DESIGN BRIEF ADDENDUM

770 SOMERSET STREET WEST

RE: 770 Somerset Street West & 13 Lebreton Street North, Ottawa
Design Brief Addendum
Zoning By-law Amendment, D02-02-17-0096
Site Plan Control Revision, D07-12-17-0136

Shadow Study Comparison – June 21

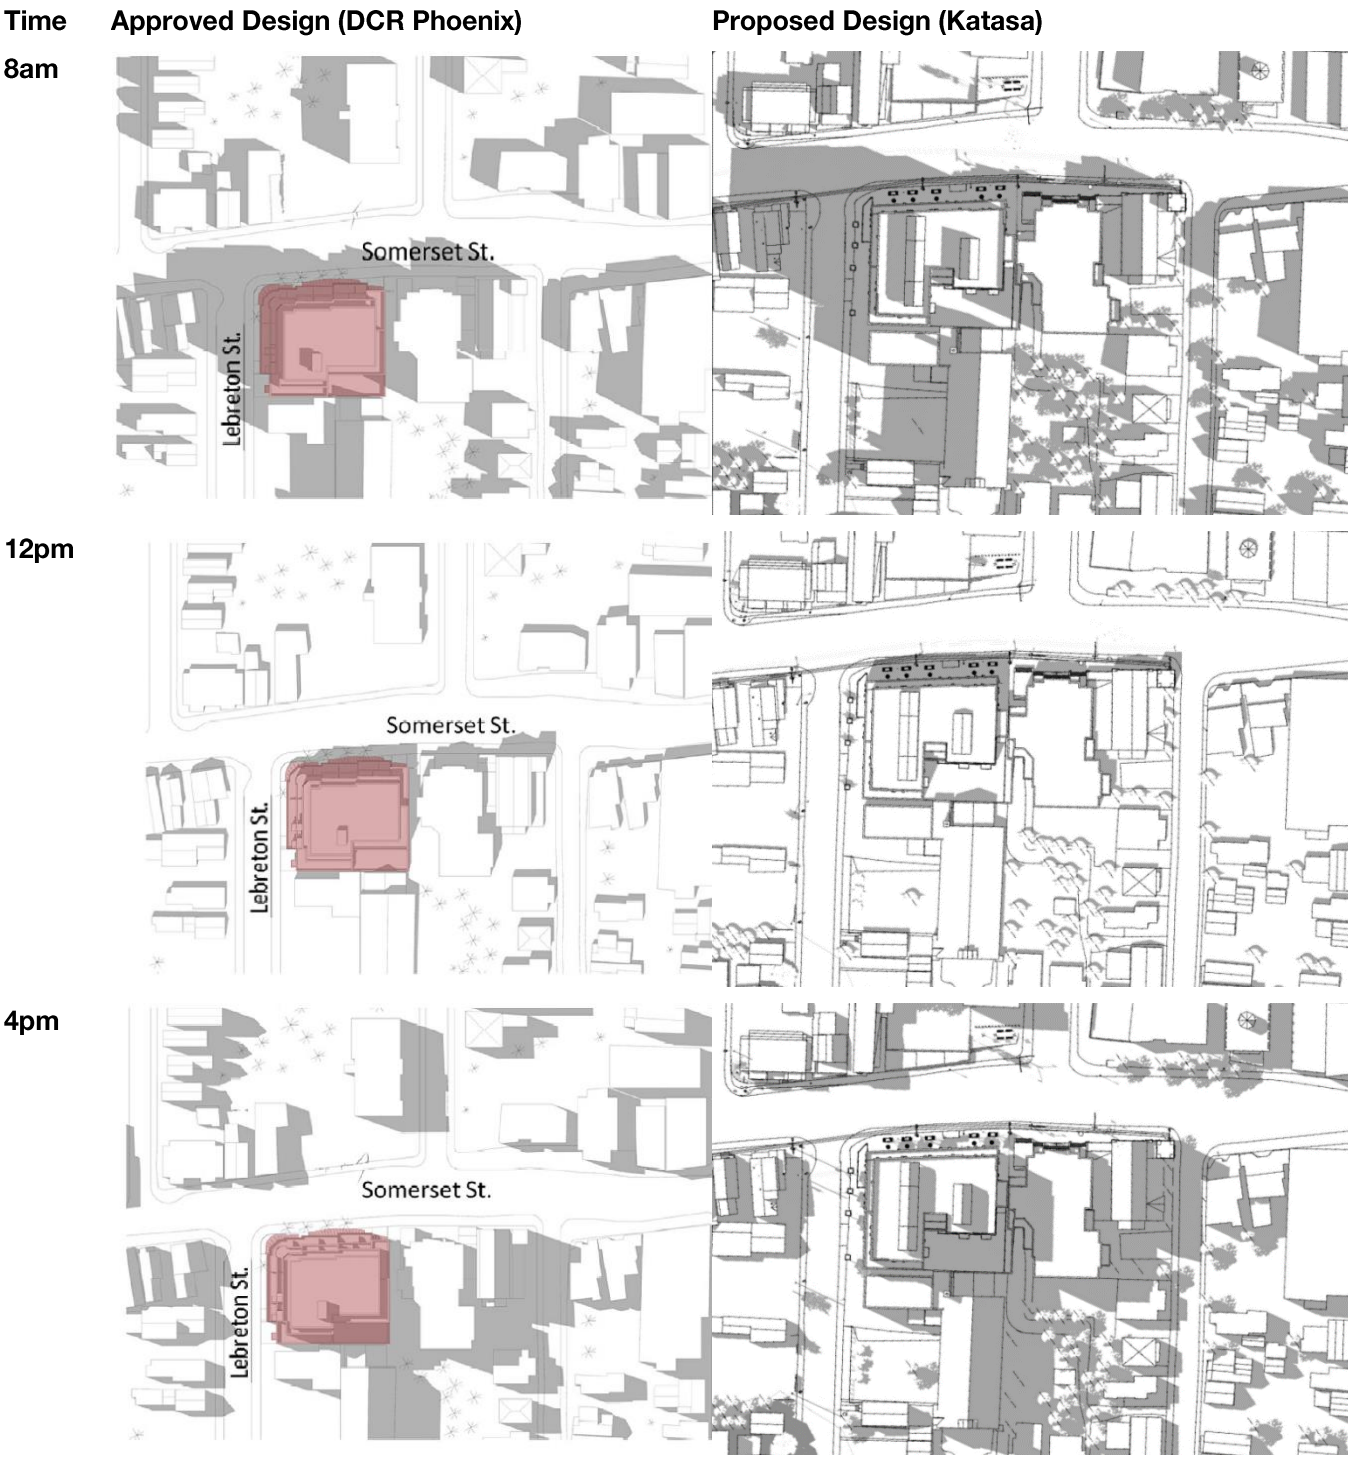
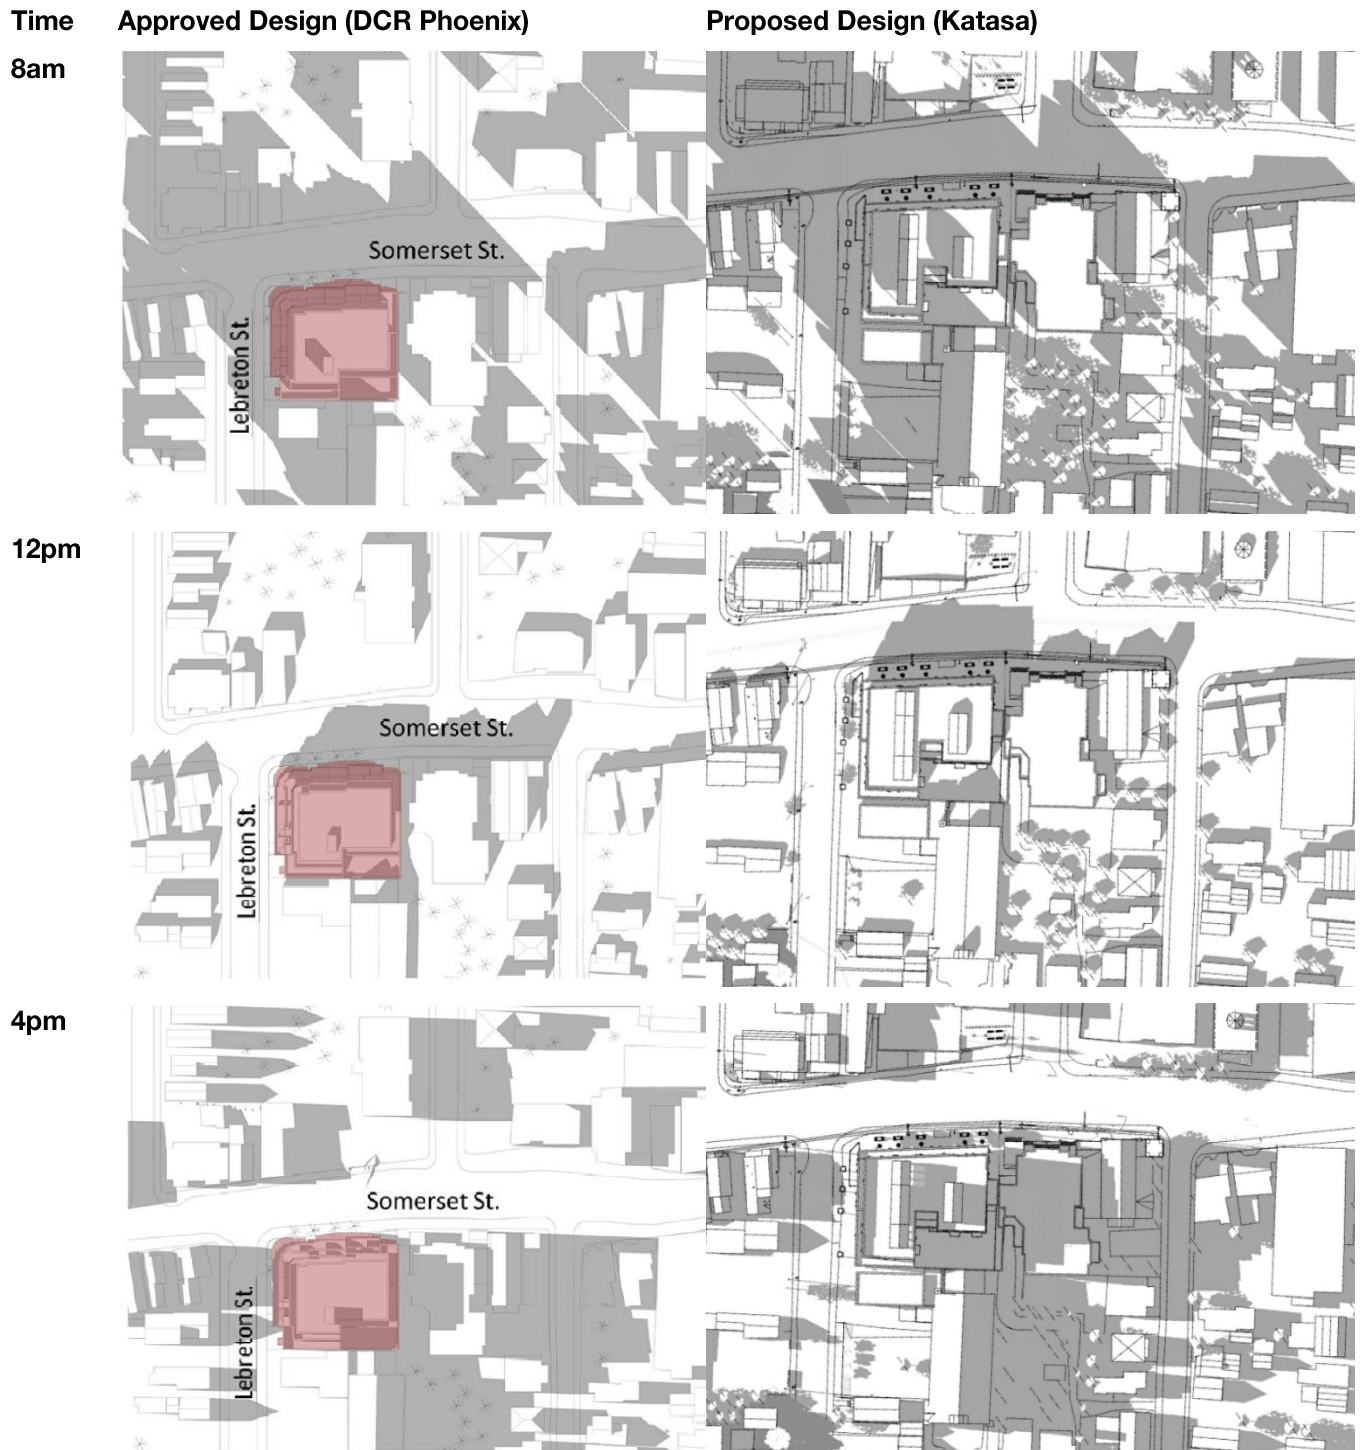
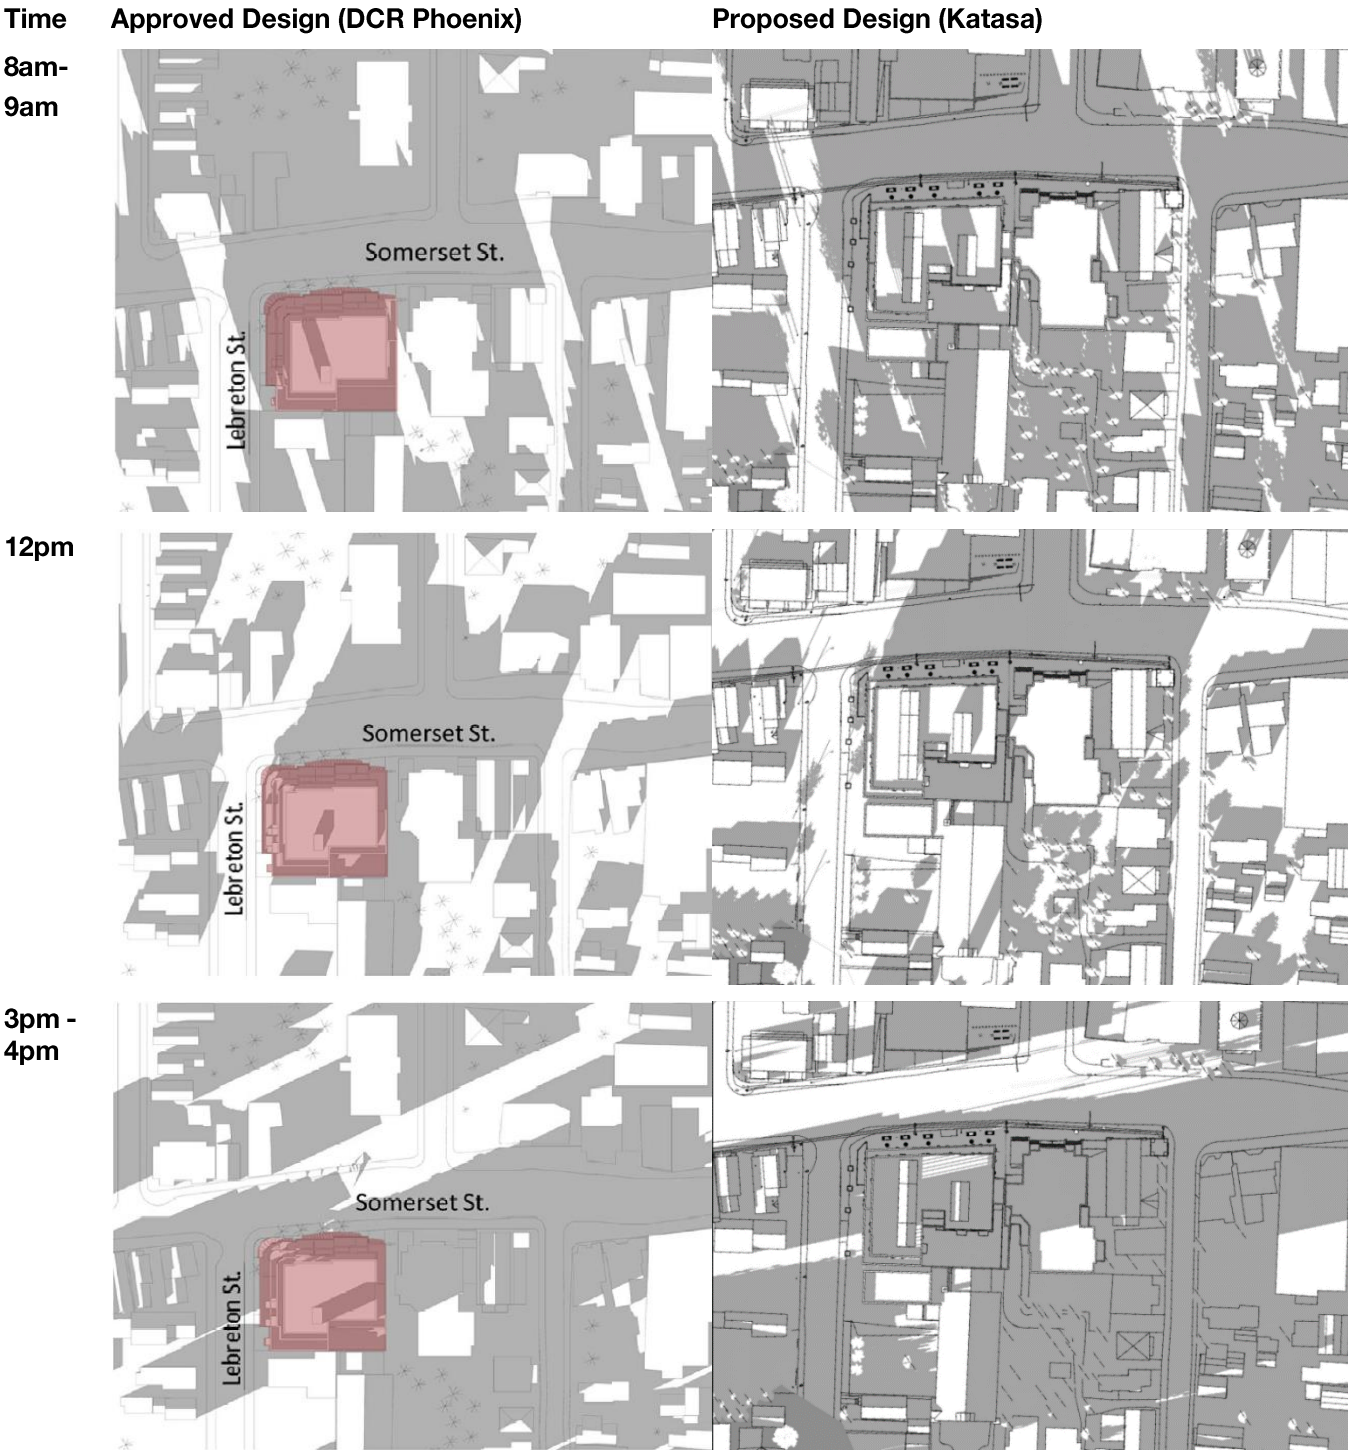
<p>deliveries will occur on Lebreton Street, adjacent to the development. This location is appropriate to minimize potential conflicts with the intersection of the streets and the required bus stop. As this section of Lebreton Street is mainly commercial, it is presumed that “unofficial” loading is already occurring in this manner and that impacts to adjacent development will be minimal.</p> <p>Garbage will be stored within the building and picked up curb-side. Commercial garbage will be picked up on Somerset Street and residential garbage will be picked up on Lebreton Street.</p>
Lighting	Lighting will be designed and installed to provide a safe and secure environment while meeting requirements for avoiding light spillover or glare to light-sensitive areas.
Noise and Air Quality	The uses proposed are not anticipated to generate significant amounts of noise, odours or emissions.
Sunlight	<p>As confirmed in the Sun Shadow Study comparisons below, shadow impacts produced by the proposed development will move quickly across the surrounding area and no undue adverse shadowing impacts are anticipated.</p> <p>In order to determine whether there is an increase in shadowing impacts as compared to the design that could be realized through the as-of-right zoning, the current Sun-Shadow Study was compared with that of the previous DCR Phoenix proposal below. The comparison illustrates that the impact is overwhelmingly similar despite the change in design.</p>
